1. PURPOSE AND SCOPE OF THIS MEMORANDUM

This memorandum summarizes a site survey performed on July 18, 2008 to evaluate the condition of ADA-mandated accessibility at the Town Hall in Pembroke Massachusetts. After a description of the site and interior conditions of the building, recommended improvements are provided in Section 7, beginning on page 8.

The subject property is the Pembroke Town Hall at 100 Center Street.

i. Door and Sill – Main (rear) entrance

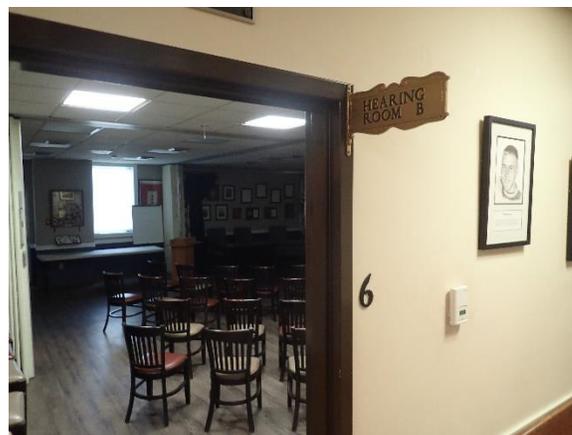
The main (lower-level) entrance is generally accessible, but the door threshold does not fully meet ADA standards. It appears that there has been an issue with site flooding around the covered entry porch. The door threshold appears to have been retrofitted to control water intrusion into the building. There is a raised wood threshold at the interior and exterior of the door. This threshold is beveled on both sides, but well exceeds the allowable total height of $\frac{1}{2}$ ". The interior side if the threshold is also worn from use and exceeds the maximum allowable vertical step of $\frac{1}{4}$ ". The door, hardware and operation are otherwise compliant.

- a. Entrance Threshold – priority repair
As noted above, the door threshold exceeds the allowable ADA height. However, the deteriorated interior portion of the threshold should be replaced to provide a consistent edge with no more than a ¼” vertical step.

- a. Entrance Threshold
In conjunction with regrading and drainage improvements around the main entrance area noted above, provide ADA-compliant entrance door system, including threshold, plus new or modified door and hardware as necessary. ADA-compliant signage, including Braille lettering at power door operators, should be included.
